GTR No. 9 – Draft proposal for Amendment 2

Note: The text reproduced below was prepared by the chairman of the informal working group on the global technical regulation No. 9 (Pedestrian safety)-Phase 2 proposing the use of a flexible pedestrian lower legform impactor in the global technical regulation No. 9 (pedestrian safety) - Phase 2. The modifications to the current text of gtr No. 9 on pedestrian safety are marked in bold for new or strikethrough for deleted characters. Text in square brackets is still under discussion and consideration of the informal group.

I. Proposal

Figure 12 Flexible lower legform impactor; Dimensions and C.G. locations of femur, knee joint and tibia (Side view)

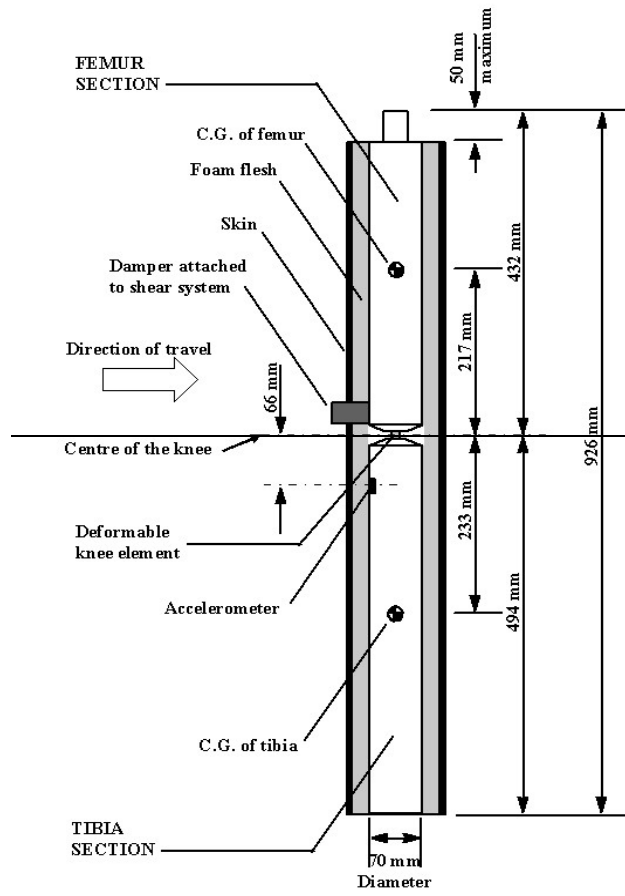
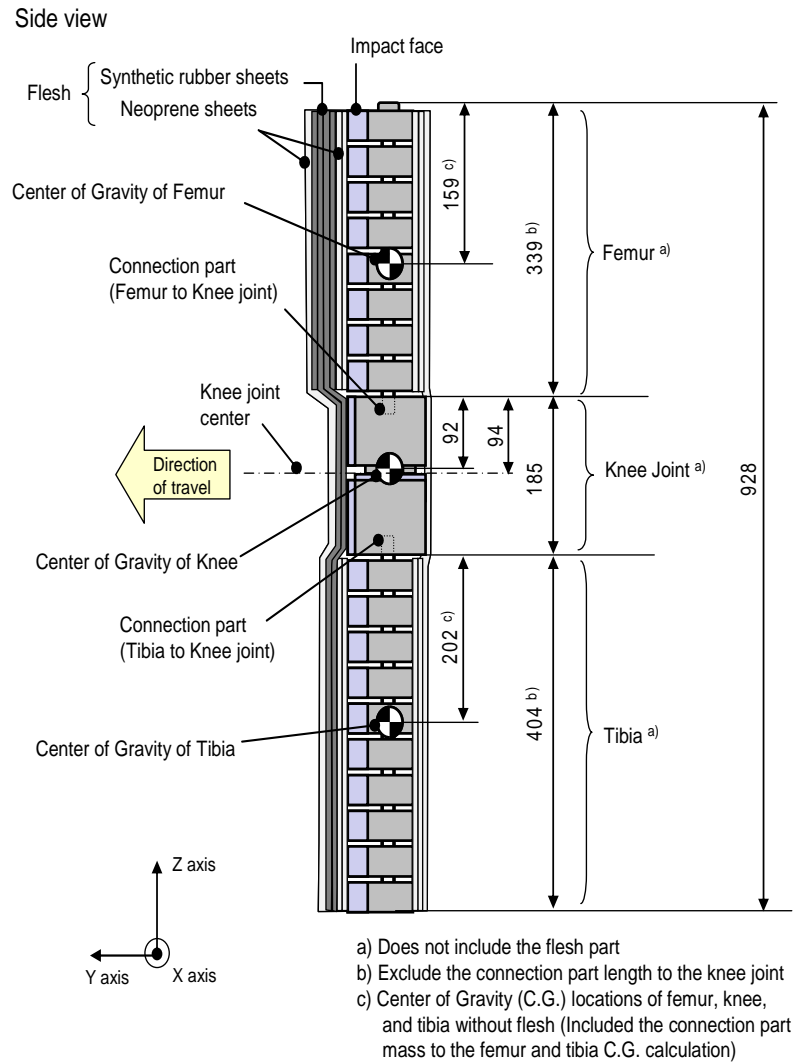
The flexible lower legform impactor shall consist of flesh, flexible long bone segments (representing femur and tibia), and a knee joint as shown in Figure 12.

The overall length of the impactor shall be 928 ± 3 mm, having a required mass of 13.2 ± 0.7 kg including flesh. The length of the femur, knee joint, and tibia shall be 339 ± 2 mm, 185 ± 1 mm, and 404 ± 2 mm

respectively. The knee joint centre position shall be 94 ± 1 mm from the top of the knee joint.

Brackets, pulleys, protectors, connection parts, etc. attached to the impactor for the purpose of launching and/or protecting may extend beyond the dimensions shown in Figure 12 and Figure 13.

The lower legform impactor shall consist of two foam covered rigid segments, representing femur (upper leg) and tibia (lower leg), joined by a deformable, simulated knee joint. The overall length of the impactor shall be 926 ± 5 mm, having a required test mass of 13.4 ± 0.2 kg (see Figure 12).

The centre of gravity of the femur and tibia without flesh, including the connection part to the knee joint, shall be 159 ± 8 mm and 202 ± 10 mm respectively from the top, but not including the connection part to the knee joint, of each part as shown in Figure 12. The centre of gravity of the knee shall be 92 ± 5 mm from the top of the knee joint as shown in Figure 12.

Delete Figures 12, to read:

Insert new Figures 12 to 16, to read:

Delete Figures 12 : delete figure for EEVC lower legform impactor.

Insert new Figures 12 to 16 : insert figures for flexible lower legform impactor.

Figure 13 flexible lower legform impactor; femur, tibia, and knee dimensions (Top view)

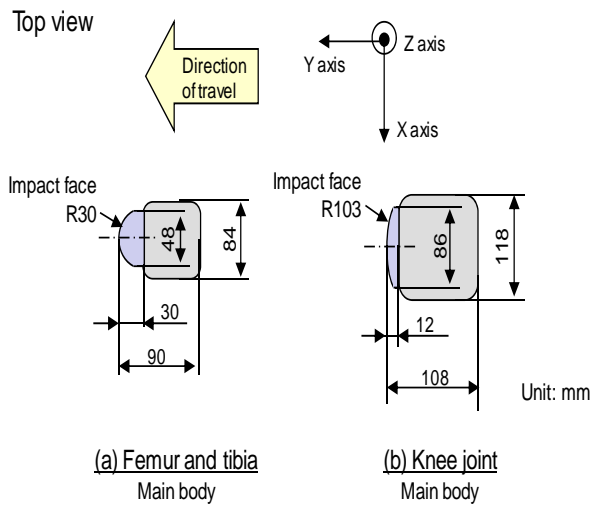
- 6.3.1.1.1. **The cross-sectional shape perpendicular to the Z-axis of the femur and tibia main bodies shall be 90 ± 2 mm in width along the Y-axis, and 84 ± 1 mm in width along the X-axis as shown in Figure 13 (a). The impact face shall be 30 ± 1 mm in radius, 30 ± 1 mm in width along the Y-axis, and 48 ± 1 mm in width along the X-axis as shown in Figure 13 (a).**

- 6.3.1.1.2. **The cross-sectional shape perpendicular to the Z-axis of the knee joint shall be 108 ± 2 mm in width along the Y-axis, and 118 ± 1 mm in width along the X-axis as shown in Figure 13 (b). The impact face shall be 103 ± 1 mm in radius, 12 ± 1 mm in width along the Y-axis, and 86 ± 1 mm in width along the X axis as shown in Figure 13 (b).**

Figure 14 Flexible lower legform impactor; flesh dimensions

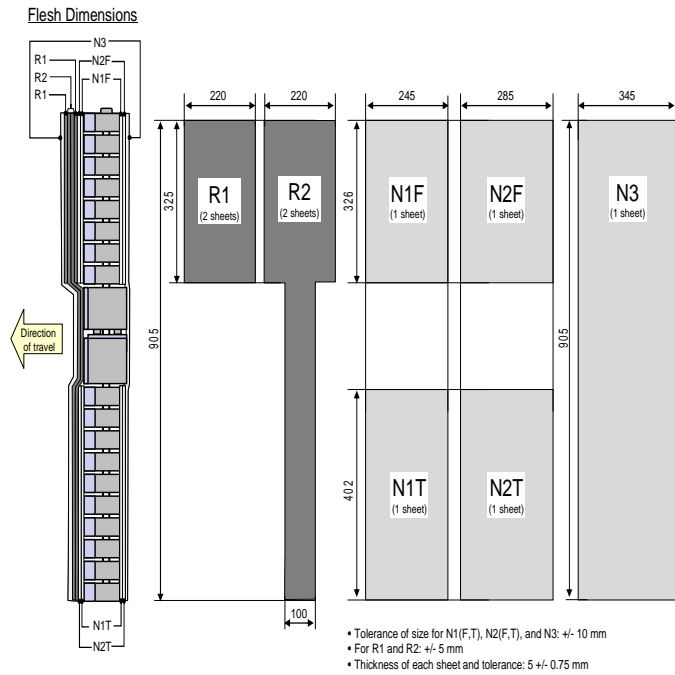
- 6.3.1.1.4. **For each test, the impactor (femur, knee joint, and tibia) shall be covered by flesh composed of synthetic rubber sheets (R1, R2) and neoprene sheets (N1F, N2F, N1T, N2T, N3) as shown in Figure 14. The sheets are required to have a compression characteristic as shown in Figure 15. The compression characteristic shall be checked using the same batch of sheets as those used for the impactor flesh. The size of the sheets shall be within the requirements described in Figure 15.**

Figure 15 Flexible lower legform impactor; flesh compression characteristics

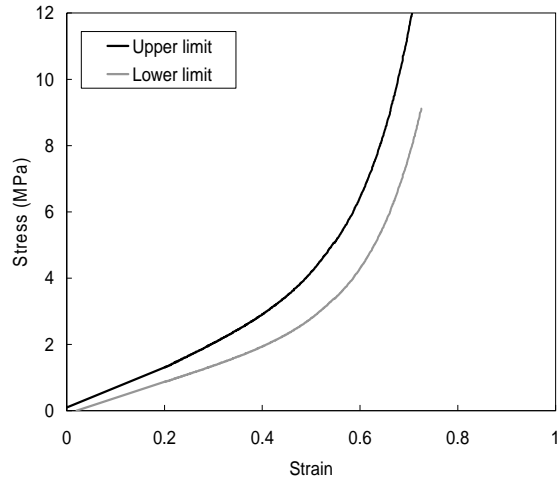
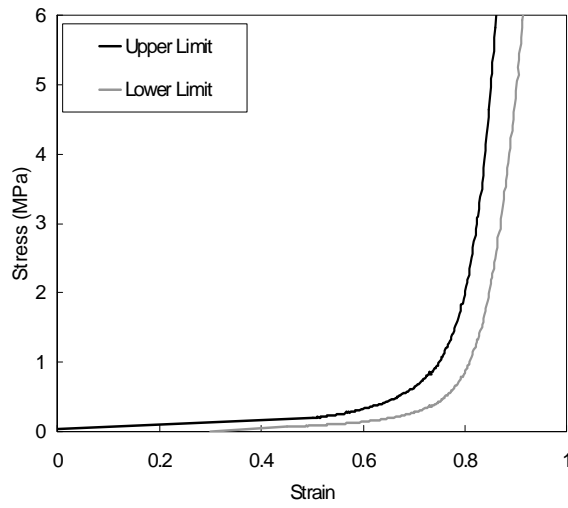
8.1.1.5. **The edges of the knee joint, not bending parts, shall be mounted to the support rig firmly as shown in Figure 26. The Y-axis of the impactor shall be parallel to the loading axis within $180 \pm 2^\circ$. In order to avoid friction errors, roller plates shall be set underneath the support rigs. To avoid impactor damage, a neoprene sheet shall be set underneath the loading ram and the impactor face of the knee joint which is described in the Figure 13 shall be removed. The neoprene sheet used in this test shall have compression characteristics as shown in Figure 15.**

Figure 16 flexible lower legform impactor; instrument locations

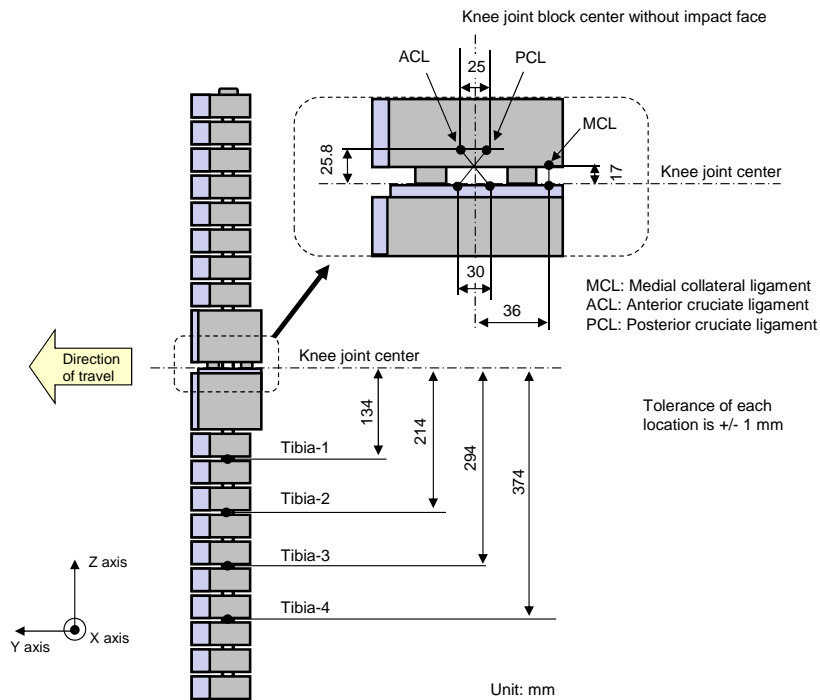
- 6.3.1.1.6.1. **Four transducers shall be installed in the tibia to measure bending moments applied to the tibia. The sensing locations of each of the transducers are as follows: tibia-1: 134 ± 1 mm, tibia-2: 214 ± 1 mm, tibia-3: 294 ± 1 mm and tibia-4: 374 ± 1 mm below the knee joint centre respectively as shown in Figure 16. The measurement axis of each transducer shall be the X-axis of the impactor.**

- 6.3.1.1.6.2. **Three transducers shall be installed in the knee joint to measure elongations of the medial collateral ligament (MCL), anterior cruciate ligament (ACL), and posterior cruciate ligament (PCL). The measurement locations of each transducer are shown in Figure 16. The measurement locations shall be within ± 4 mm along the X-axis from the knee joint centre.**

Figure 21 Flexible lower legform impactor Lower legform to bumper tests for complete vehicle in normal ride attitude (left) and for cut-body mounted on supports (right) (see paragraph 7.1.1.3.) "

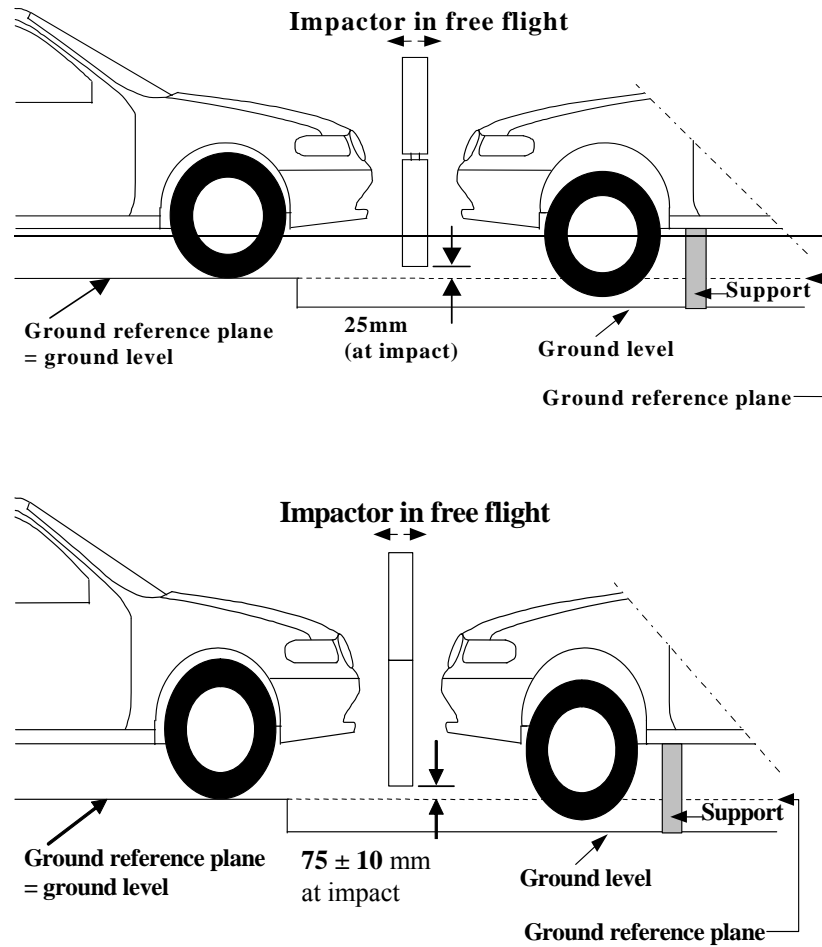
7.1.1.3. **The bottom of the impactor shall be at 75 mm above ground reference plane at the time of first contact with the bumper (see Figure 21), with a ± 10 mm tolerance. When setting the height of the propulsion system, an allowance must be made for the influence of gravity during the period of free flight of the impactor.**

~~The bottom of the impactor shall be at 25 mm above ground reference plane at the time of first contact with the bumper (see Figure 17), with a ± 10 mm tolerance. When setting the height of the propulsion system, an allowance must be made for the influence of gravity during the period of free flight of the impactor.~~

Figures 17(former), renumber as Figure 21 and amend to read:

Figure 17 (former): renumbering and replaced by flexible lower legform impactor requirements.

Figure 18: Force versus angle requirement in static lower legform impactor bending certification test (see paragraph 8.1.1.2.)

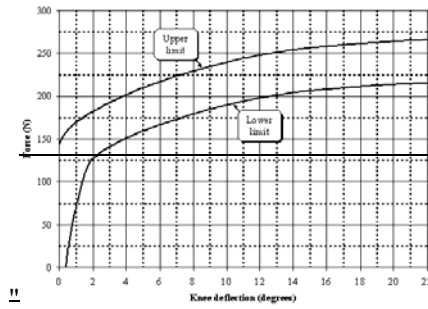
~~When the impactor is loaded in bending in accordance with paragraph 8.1.1.4., the applied force/bending angle response shall be within the limits shown in Figure 18. Also, the energy taken to generate 15.0° of bending shall be $100 \pm 7\text{ J}$.~~

Delete Figures 18 to Figure 21, to read:

Delete Figures 18 to Figure 21 : delete figure for EEVC lower legform impactor.

Figure 19: Force versus displacement requirement in static lower legform impactor shearing certification test (see paragraph 8.1.1.3.)

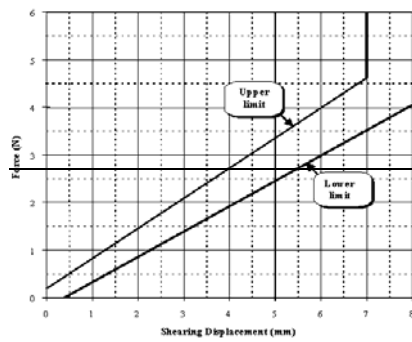
~~When the impactor is loaded in shearing in accordance with paragraph 8.1.1.5., the applied force/shearing displacement response shall be within the limits shown in Figure 19.~~

Figure 20: Top View of Test set up for static lower legform impactor bending certification test (see paragraph 8.1.1.4.)

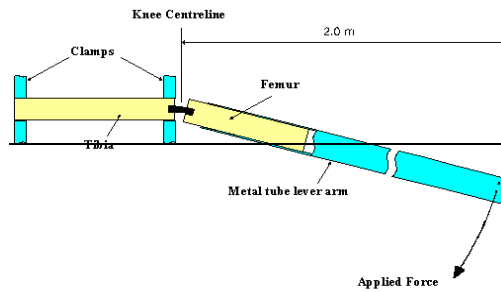
~~The impactor, without foam covering and skin, shall be mounted with the tibia firmly clamped to a fixed horizontal surface and a metal tube connected firmly to the femur, as shown in Figure 20. The rotational axis of impactor knee joint shall be vertical. To avoid friction errors, no support shall be provided to the femur section or the metal tube. The bending moment applied at the centre of the knee joint, due to the mass of the metal tube and other components (excluding the legform itself), shall not exceed 25 Nm.~~

Figure 21: Top View of Test set-up for static lower legform impactor shearing certification test (see paragraph 8.1.1.5.)

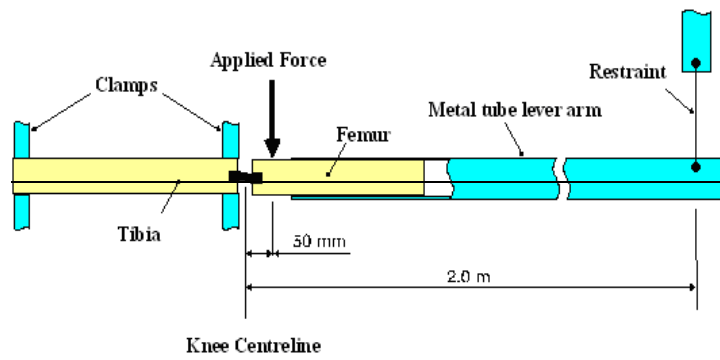
~~The impactor, without foam covering and skin, shall be mounted with the tibia firmly clamped to a fixed horizontal surface and a metal tube connected firmly to the femur and restrained at 2.0 m from the centre of the knee joint, as shown in Figure 21.~~

Figure 22: Test set-up for dynamic lower legform impactor certification test (side view top diagram, view from above bottom diagram) (see paragraph 8.1.2.4.1.)"

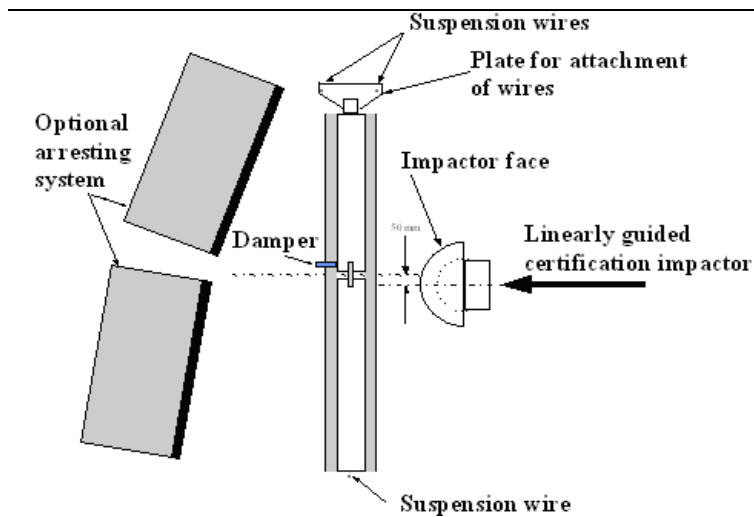
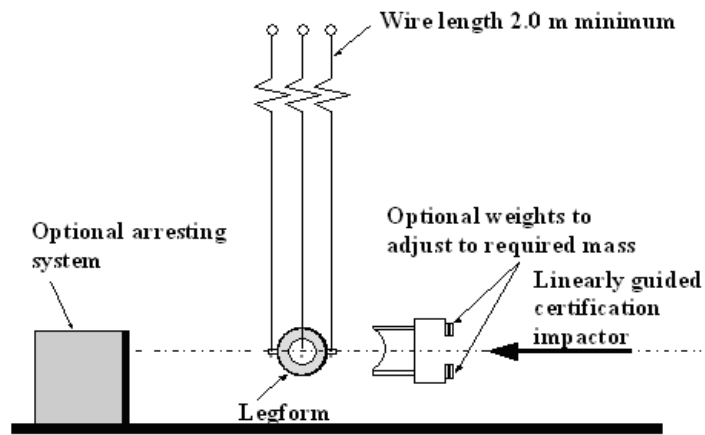
~~The impactor, including foam covering and skin, shall be suspended horizontally by three wire ropes of 1.5 ± 0.2 mm diameter and of 2000 mm minimum length, as shown in Figure 22. It shall be suspended with its longitudinal axis horizontal, with a tolerance of $\square 0.5^\circ$, and perpendicular to the direction of the certification impactor motion, with a tolerance of $\square 2^\circ$. The impactor shall have the intended orientation about its longitudinal axis, for the correct operation of its knee joint, with a tolerance of $\pm 2^\circ$. The impactor must meet the requirements of paragraph 6.3.1.1., with the attachment bracket(s) for the wire ropes fitted.~~

Figure 22 Flexible lower legform impactor requirement corridor of femur and tibia in static certification test
(see paragraph 8.1.1.2.)

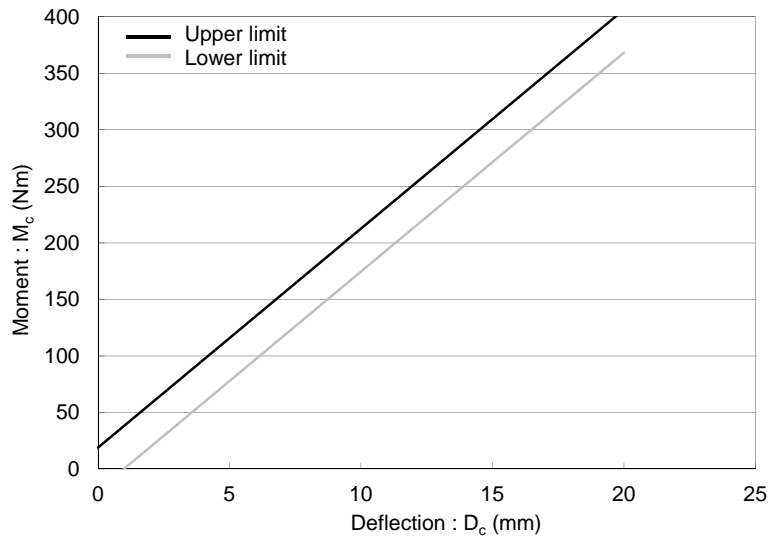
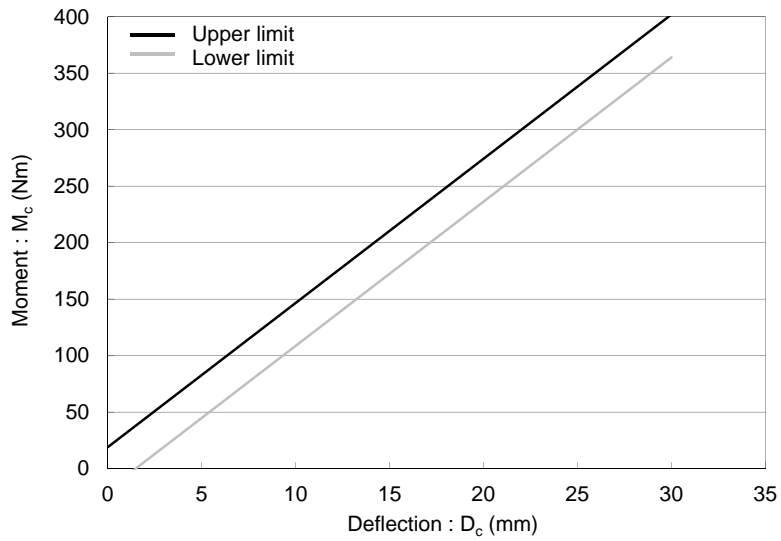
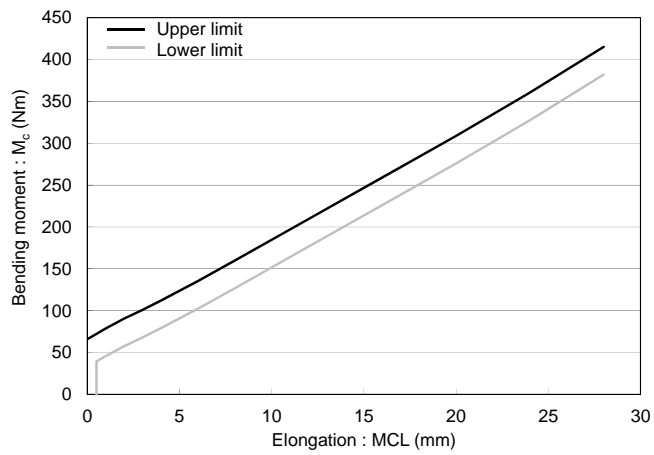
8.1.1.2. **When the femur and tibia of the impactor are loaded in bending in accordance with paragraph 8.1.1.4., the applied moment and generated deflection at the centre of the femur and tibia (M_c and D_c) shall be within the corridors shown in Figure 22.**

Figure 23 Flexible lower legform impactor requirement corridors for knee joint in static certification test (see paragraph 8.1.1.3.)

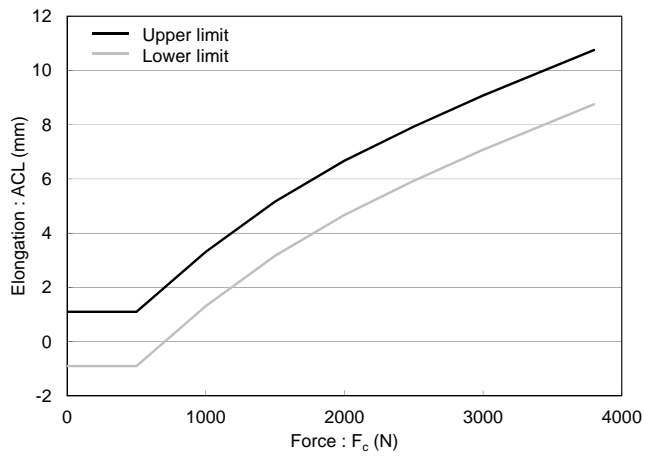
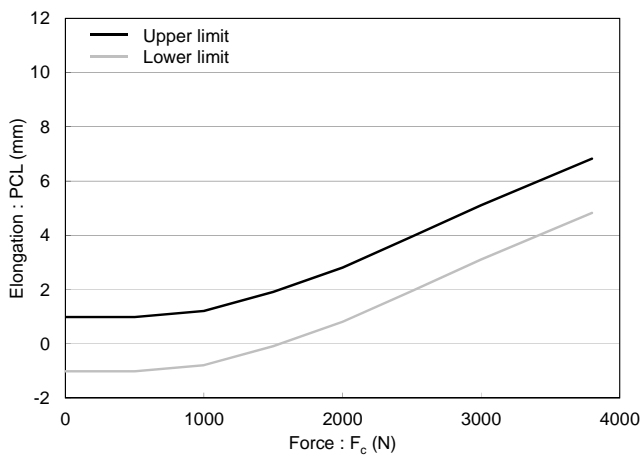
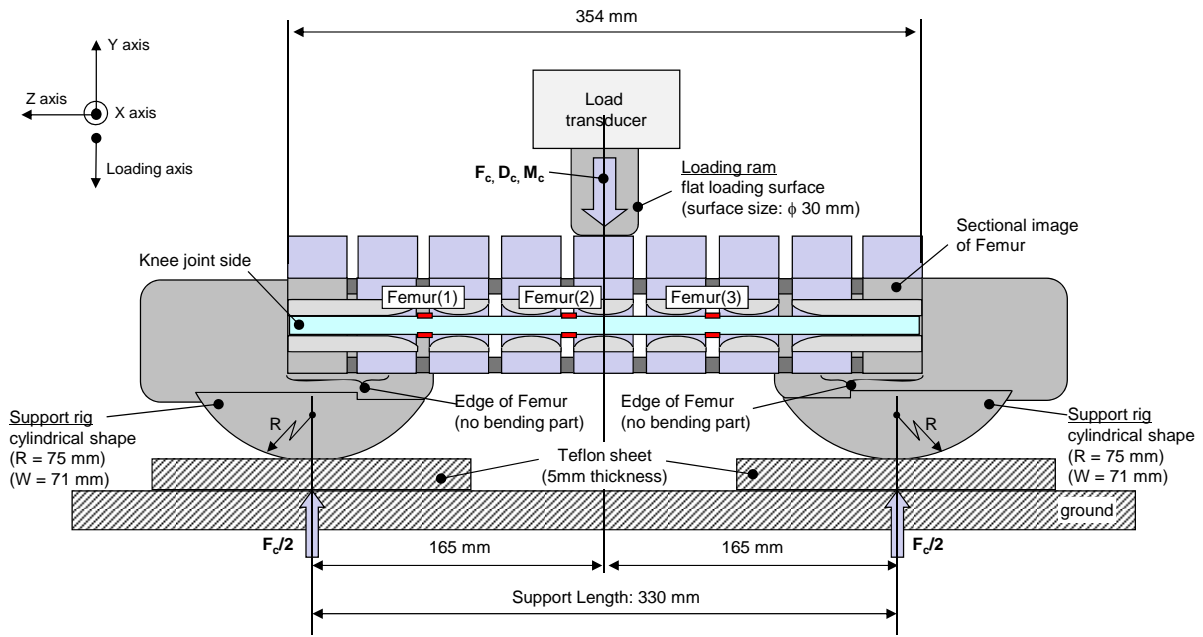
8.1.1.3. **When the knee joint of the impactor is loaded in bending in accordance with paragraph 8.1.1.5., the MCL, ACL, and PCL elongations and applied bending moment or force at the centre of the knee joint (M_c or F_c) shall be within the corridors shown in Figure 23.**

Figure 24 Flexible lower legform impactor test set-up for femur in static certification tests

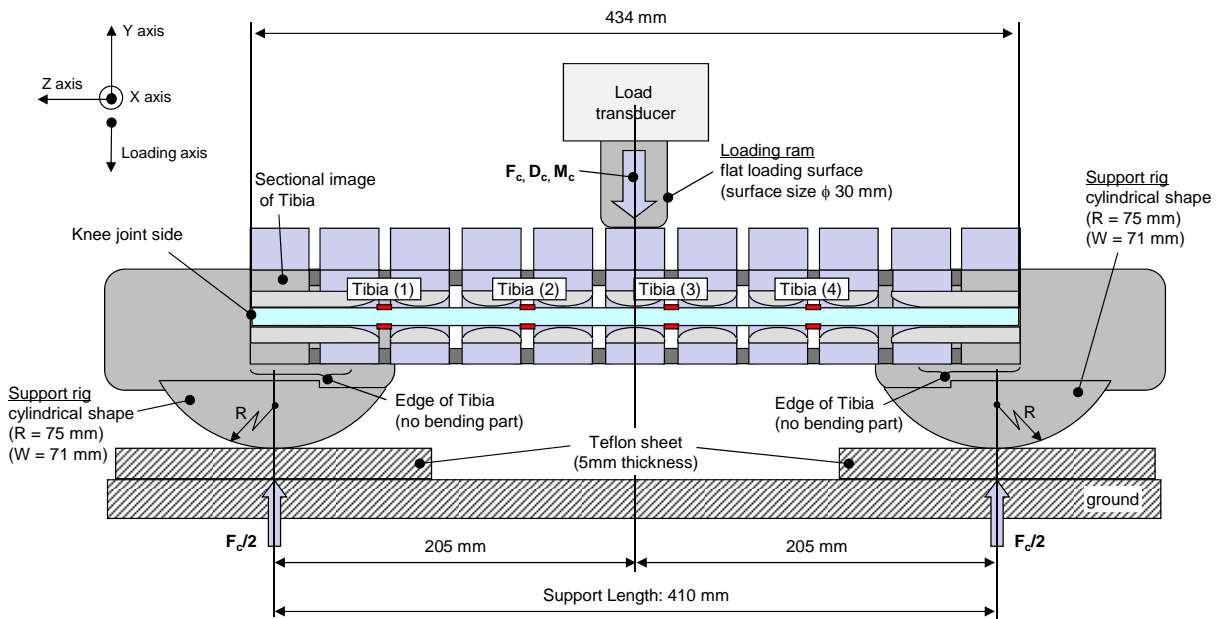
8.1.1.4. **The edges of the femur and tibia, not bending parts, shall be mounted to the support rig firmly as shown in Figure 24 and Figure 25. The Y-axis of the impactor shall be parallel to the loading axis within $180 \pm 2^\circ$ tolerance. In order to avoid friction errors, roller plates shall be set underneath the support rigs.**

The centre of the loading force shall be applied at the centre of the femur and tibia within $\pm 2^\circ$ tolerance along the Z-axis. The force shall be increased at a rate between 10 and 100 mm/minute until the bending moment at the centre part (M_c) of the femur or tibia reaches 400 Nm.
